**LOCAL HISTORIC DISTRICT:** Wilmore

**PROPERTY ADDRESS:** 1513, 1515, 1521 South Mint Street

**SUMMARY OF REQUEST:** Commercial building rehabilitation (fenestration, murals, signage, awnings, lighting)

# HDCCMA 2019-00367

Proposed Elevations

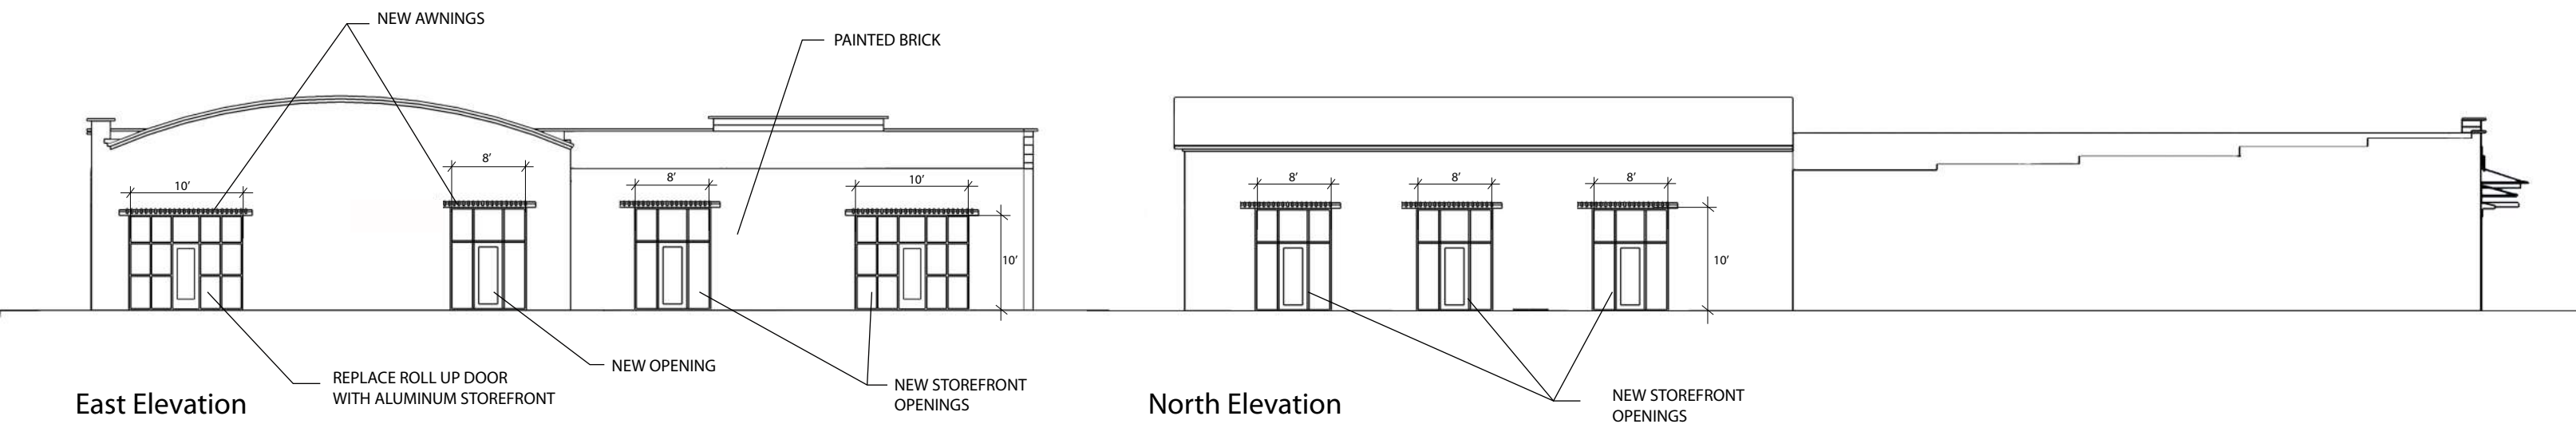
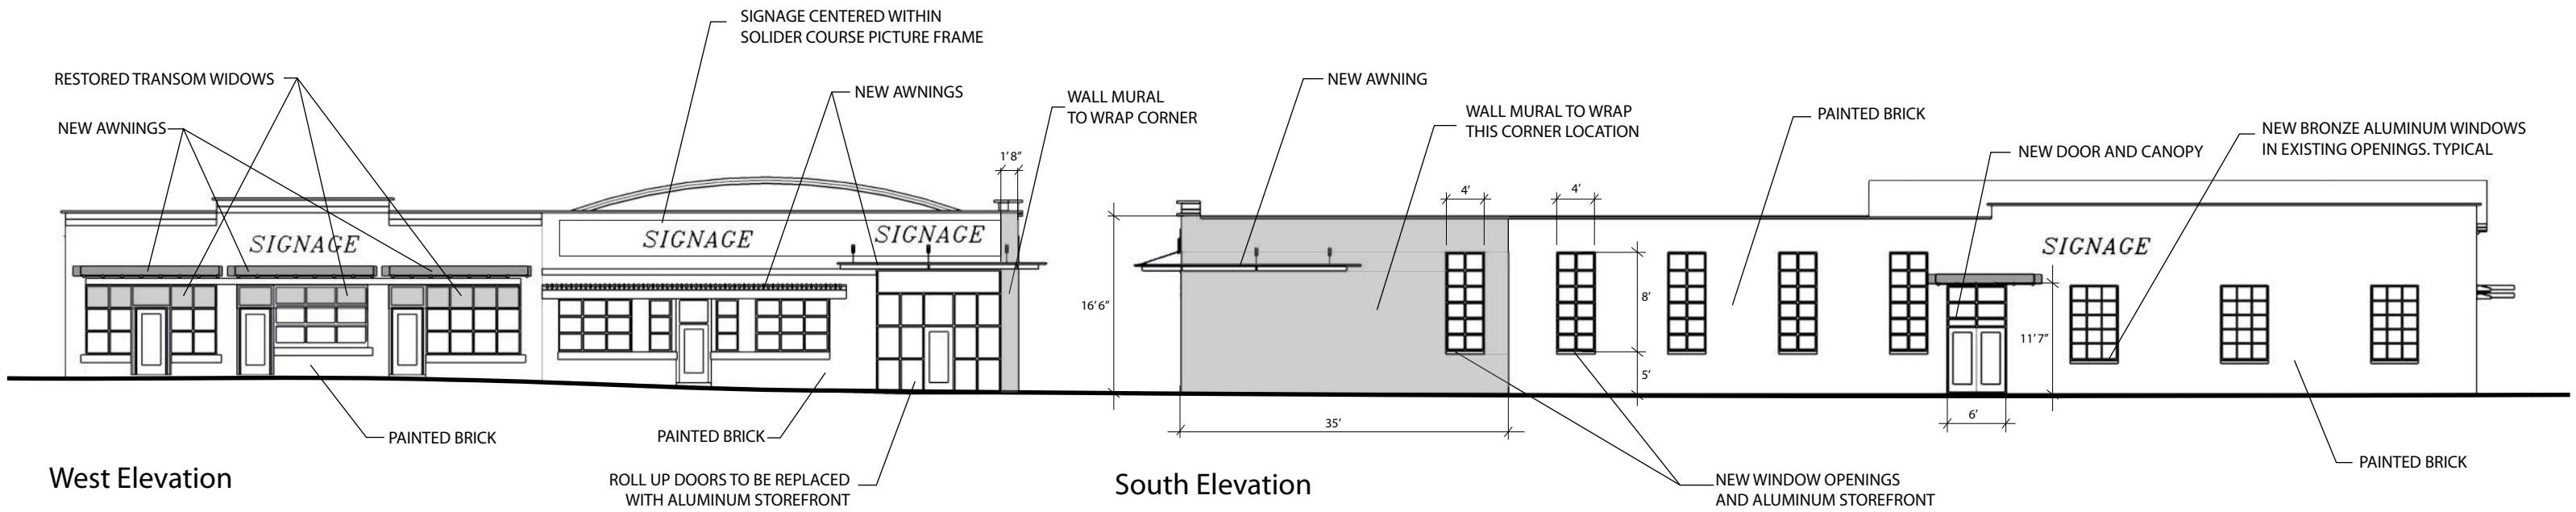
1. Awnings may be reviewed under 'Additions'.
2. Limit LED lighting warmth levels to 2000-3000k.
3. Verify that signage meets HDC standards in addition to the TOD standards outlined in the proposal.
4. For the 'subject to change' elements (e.g.: awning material and location, window/door opening details, and signage, etc.) if there are no other questions or concerns with the overall design, then Staff recommends:
  - a. Approval with the following Conditions:
    - Detailed plans be brought back to the Commission for full review once the project has progressed and tenants are confirmed. Detailed plans include but are not limited to: windows and doors, signage, canopies/awnings, lighting, parking screening, and murals.
    - Nothing in this approval guarantees a COA will be granted for future plans submitted to the Commission.
